Application for Fence Exemption - 48 Lankin Boulevard

Date: May 31, 2022
To: Toronto and East York Community Council
From: District Manager, Municipal Licensing and Standards
Wards: 14

Attachment # 2: North and West view of fence from the deck

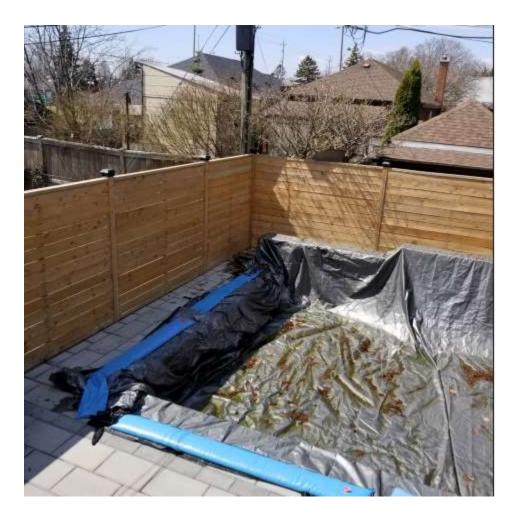
The newly constructed wood fence in the rear yard of the property is located less than 1.2 Meters from the water's edge for all three sides except from the porch which is east of the swimming pool. The distance from the fence to the water's edge are as follows; north side -0.90 metres, west side -1.0 metre, south side -1.15 metres. While the proposed fence violates Toronto Municipal Code, Chapter 447- Fences with respect to a fence less than 1.2 Metres from the water's edge in the pool, from the west north and south side of the rear yard, it does not appear to contravene any other provisions of the bylaw.
